# **New Construction Lock Up Report**

Inspection Date: 23 Jun 2020

Property Address: Rockbank Area

Report Type: New Home Construction

### Non Compliant 2.04

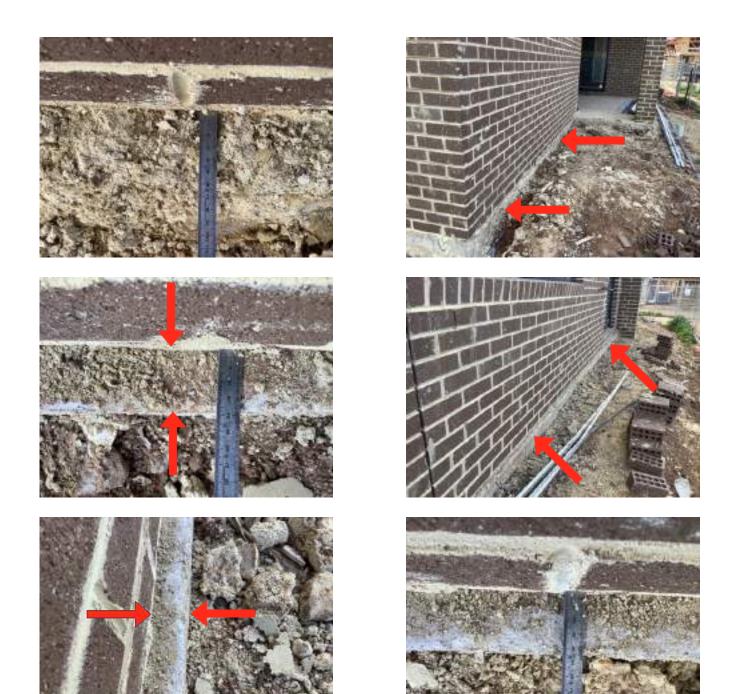
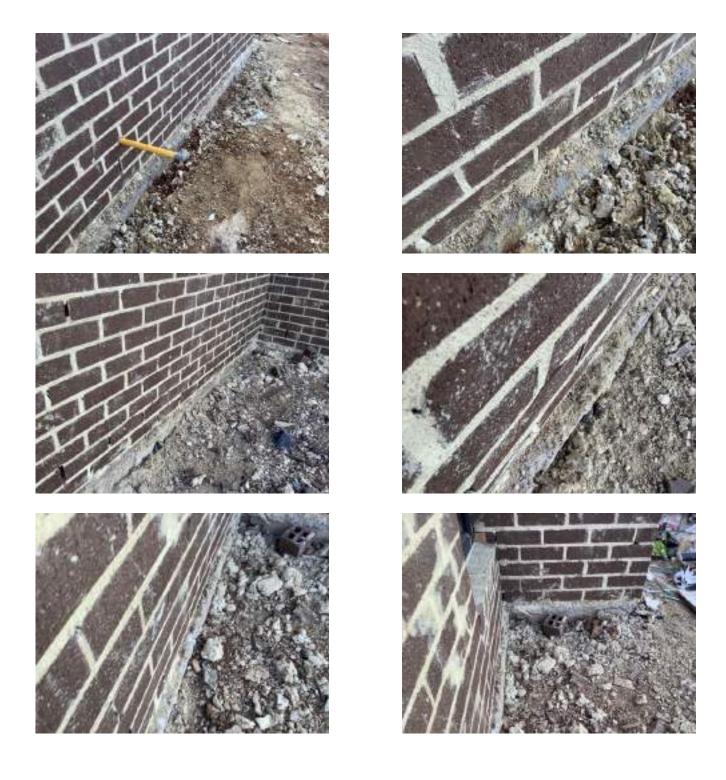
Location: Brick Work - Exterior Perimeter Of Building

Finding: Bricks Base - Overhang Of Slab.

It was observed that there are areas where the edge of the slab protrudes past the document finished dimension of the slab. There are many areas to the total perimeter of the home that

have EXCESSIVE concrete slab.

The edges of the slab needs to be trimmed back in line with the brickwork face edge. It appears the boxing on the slab may have bulged out which occurs when insufficient

pegging and bracing is provided prior to the concrete pour.

The current overhang will affect any concrete pavement of hard material landscaping such as

pavers and as such the overhang needs to be cut back.
